UNITED STATES PATENT AND TRADEMARK OFFICE

APPLICATION NO.	FILING DATE	FIRST NAMED INVENTOR	ATTORNEY DOCKET NO.	CONFIRMATION NO.
10/771,654	02/03/2004	Peter W. Gavin	34814-10123	3525
2574	7590	06/12/2007		
JENNER & BLOCK, LLP ONE IBM PLAZA CHICAGO, IL 60611			EXAMINER WENDELL, MARK R	
			ART UNIT	PAPER NUMBER
			3609	
			MAIL DATE	DELIVERY MODE
			06/12/2007	PAPER

Office Action Summary

DETAILED ACTION

Figure 6 of Campbell et al.

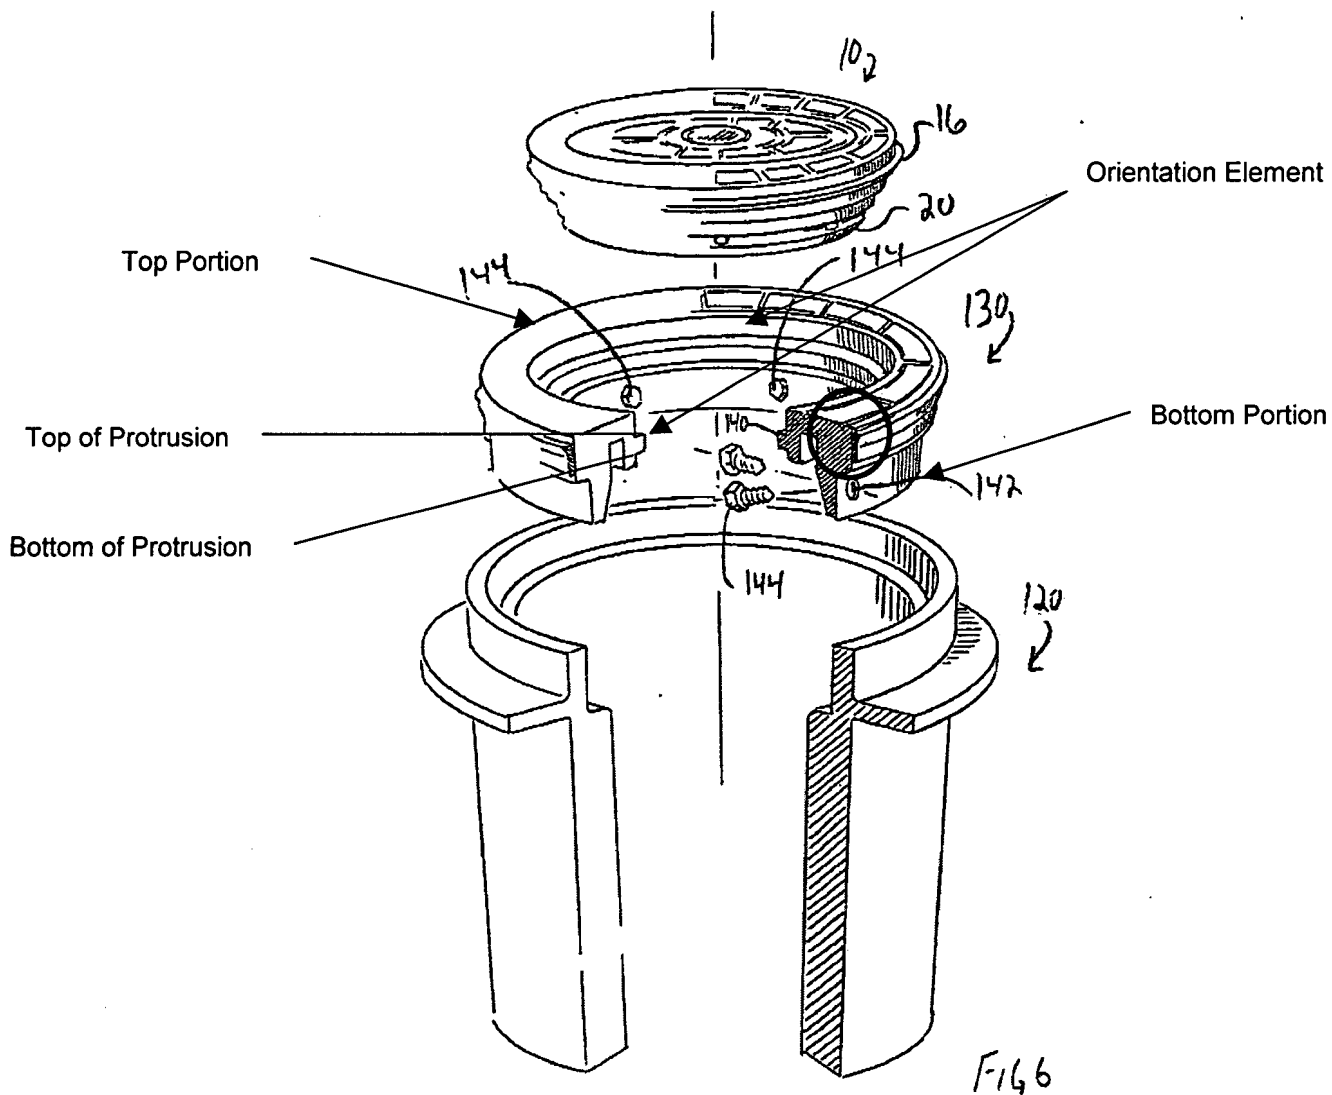
Claims 1-17, 19-25, 27-30, 32-37, 39-42 are rejected under 35 U.S.C. 102(e) as being anticipated by Campbell et al. (US Patent Application Publication Number US 2002/0166291). Campbell illustrates in Figure 6 a casting riser pan (130) comprising:

- An annular wall having a top and bottom portion (see modified figure below);
- An annular wall defining the periphery of a cover;
- An annular wall including an orientation portion forming an orientation element.

Regarding claim 3, Campbell illustrates in Figure 6 the casting riser pan (130) tapering radially outward from bottom to top. The examiner notes that the circled portion in the figure above is tapered outward further than the labeled bottom portion, thus giving rise to the casting riser pan tapering radially outward from bottom to top.

Regarding claims 4-9, Campbell illustrates in Figure 6 the casting riser pan wall having an upper and lower portion and a protruding transverse shoulder (140) extending inwardly between the two.

Regarding claims 6 and 7, the orientation element (labeled above) comprises a protrusion (140), having a top and bottom portion, extending radially inward, thus defining a recess (20) in the cover.

Regarding claim 20, Campbell illustrates in Figure 6 a casting riser pan (130) with the outer wall extending angularly outward from the inner wall. The outer wall extends outwardly at an angle of 180 degrees, which meets the limitation of extending angularly outward.

Regarding claim 23, Campbell illustrates in Figure 6 a casting riser pan (130) with the inner wall tapering radially outward from bottom to top.

Regarding claims 24-26, 28-31, Campbell illustrates in Figure 6 the casting riser pan wall having an upper and lower portion and a protruding transverse shoulder (140) extending inwardly between the two. Campbell also discloses the top portion of the protrusion being narrower than the bottom, where the indentation of the inner wall defines a protrusion from the cover.

Regarding claim 30, see modified Figure 6 of Campbell above. The indentation in the inner wall is labeled, which defines one of the multiple protrusions in the cover (10).

Figure 6 of Campbell

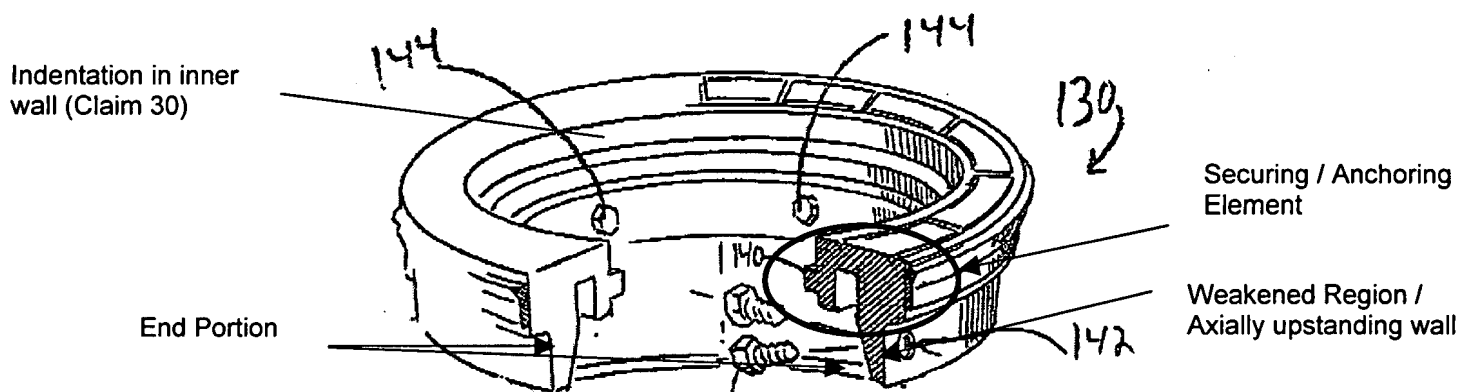
Regarding claims 10-16, Campbell illustrates in Figure 6 a casting riser pan comprising:

- A securing element extending radially inward from the bottom portion of the wall (see modified figure below);
- A weakened region connecting the securing element to the bottom portion;
- A securing element including attachment holes (142) with fasteners;
- An end portion to be received by a stackable riser (120).

Regarding claim 17, Campbell illustrates in Figure 6 a casting riser pan (130) in combination with a stackable riser (120).

Regarding claims 36 and 37, Campbell illustrates in Figure 6 an annular anchor element (see modified figure above) extending radially outward from the outer wall.

Regarding claim 40, Campbell illustrates in Figure 6 (see modified figure above), a casting riser pan (130) with the end portion including an axially extending upstanding wall.
